## MEMORANDUM

**To:** Montgomery Township Zoning Board of Adjustment

**Re:** **Renard Management, Inc.**  
**Use Variance, Height Variance, FAR Variance, Major Site Plan**  
1026 County Road 518  
Block 29002, Lots 49 and 50  
HC Highway Commercial District

**Date:** November 22, 2023

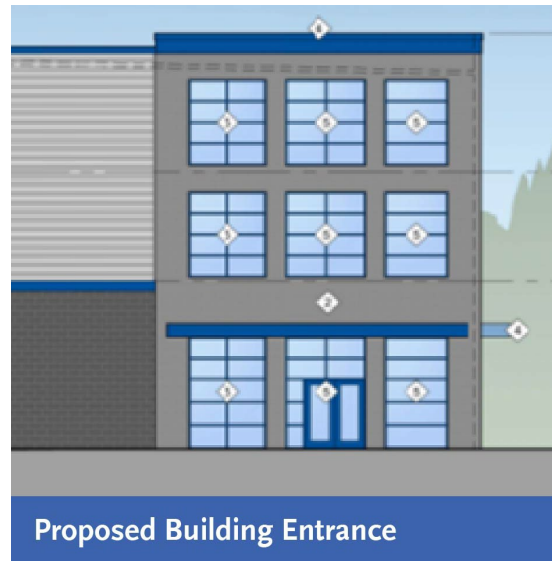
each facade. Long, monotonous, uninterrupted walls are not permitted. The outer walls do not contain any breaks or offsets and continue the same pattern from end to end on each side. **Variance relief is required.**

- 10.8. Wall Offsets:** *Variance relief is required.* §16-4.12e.5(b) requires that to the extent appropriate to the architectural design, building wall offsets, including projections such as balconies and canopies, recesses, and changes in floor

levels shall be used to add architectural interest and variety and to mitigate the visual appearance of a simple, long wall. Only the southern elevation, which faces County Road 518, contains offsets. The building is otherwise flat. **Variance relief is required.**

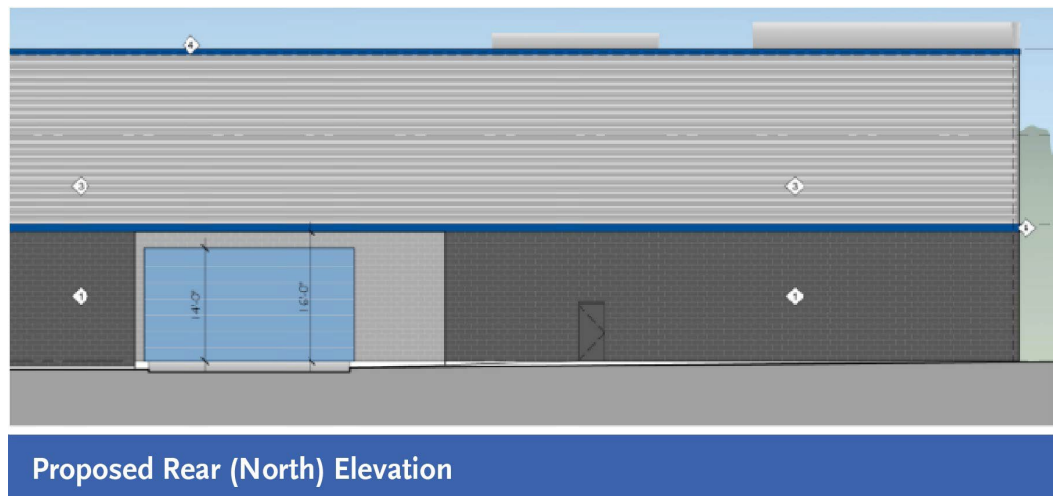
- 10.18. **Building Design Character:** The proposed building is industrial in appearance, reading as a warehouse. It will also require several variances relating to building design, which is further discussed in section 11. The industrial appearance of the proposed building is out of character with the neighborhood and the existing buildings within the HC district. As indicated below, the proposed materials include black and gray brick, metal siding, blue metal trim and glazing.

The design of the building is in contrast to the more prevalent approach to building design in the area, which leans towards more traditional design. Additionally, the neighboring municipality, Rocky Hill Borough, is adjacent to the proposed site. The portion of Rocky Hill near the site is primarily residential, with nearby single-family detached dwellings and attached townhomes. It is recommended that the applicant take a different design approach regarding the building. Images of some of the nearby buildings are included herein. Recommendations for design changes are also indicated below.

**10.19. Alternative Design Recommendation:** It is recommended that the applicant utilize a more traditional design approach, rather than a contemporary, minimalist industrial design, for the proposed building if the application is looked upon favorably. A similar facility, CubeSmart, recently opened a location in Somerset New Jersey on Somerset Street that is designed to look like a more traditional industrial building with high-quality finishes and more robust articulation of facades. From certain perspectives, it reads as a contemporary multifamily or mixed-use commercial/residential building which is far more desirable. The brick finishes and clean, modern design elements and articulation, as well as a modern, decorative awning are desirable elements. However, it's not all good: there are large expanses of blank walls, an excessive height and large scale block at the base of the building that suggest a less "human-oriented" use. This office recommends that the proposed building be redesigned in a manner that takes its cue from the existing desirable buildings in the vicinity and the HC district, which may include desirable elements expressed in the Somerset self-storage facility.
